**OLYMPIA DESIGN REVIEW BOARD  
RECOMMENDATION**

**CONCEPTUAL DESIGN REVIEW**

PROJECT NAME: Bayan Trails Multifamily PROJECT No.: 14-0139

PROJECT DESCRIPTION: Construction of multifamily development – four senior apartment buildings (168 units), ten townhome-style apartment buildings (70 units), community building, pool building, parking, pathways, raised garden beds, outdoor seating areas and viewing platform.

**TOWNHOME**  
**FLOOR PLANS**

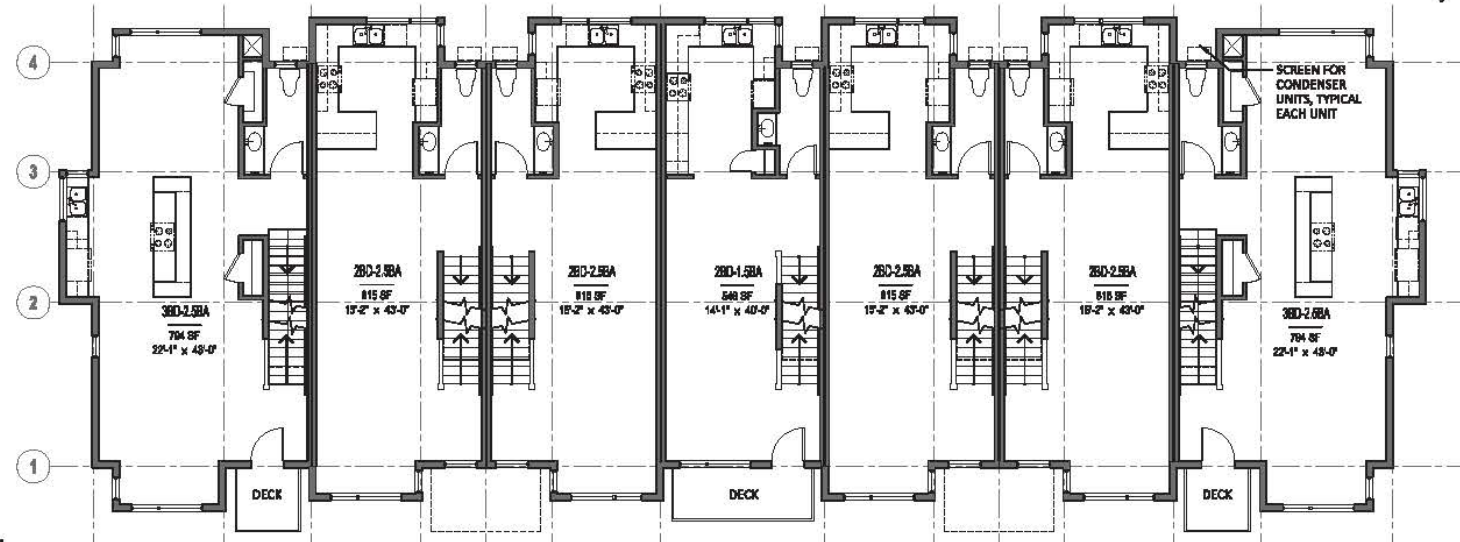
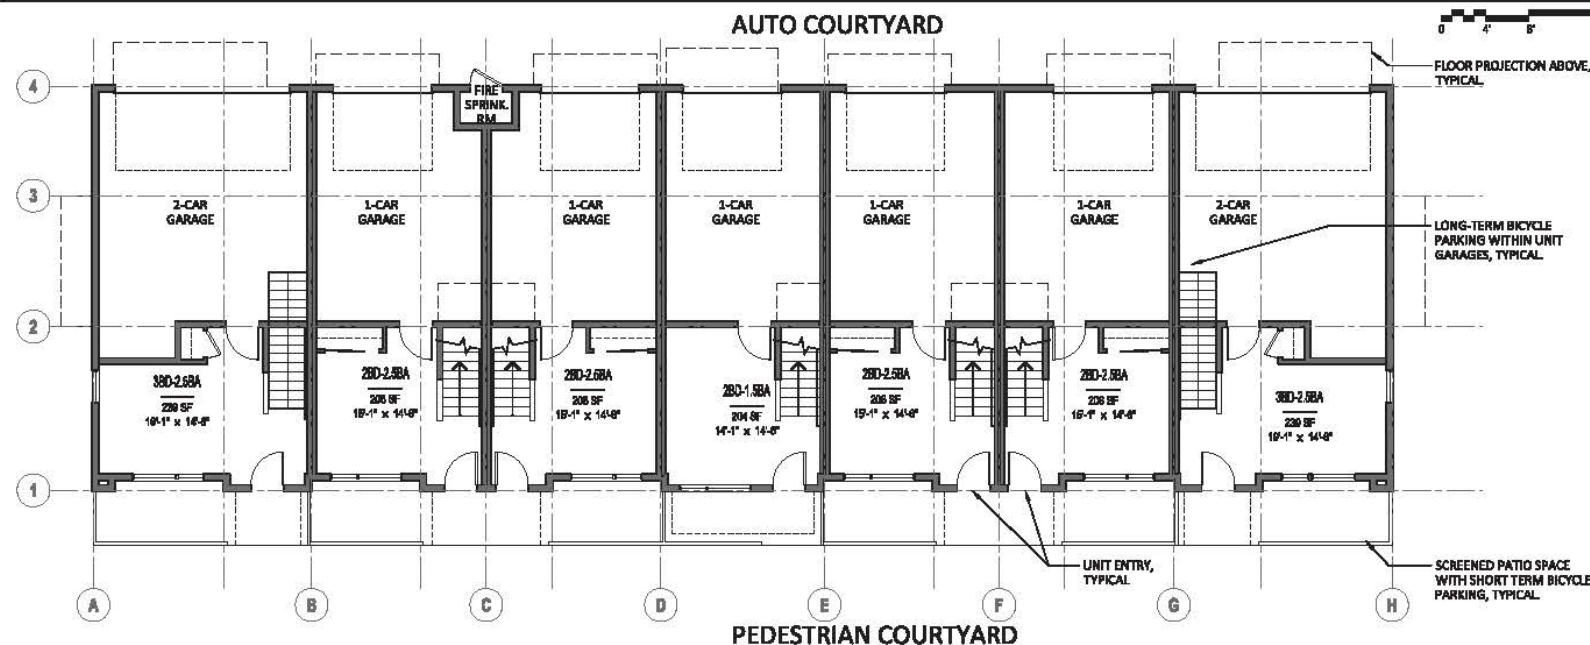
*As designed, windows provide relief, detail, and rhythm. Greater attention should be given to window placement and privacy within units. For example, kitchen and bedroom windows on the townhome units are directly across from each other. This has been included as a recommended condition of approval in the staff report. Additional detail will be required at the time of Detail Design Review for frame dimensions, sill depth, trim width, etc.*
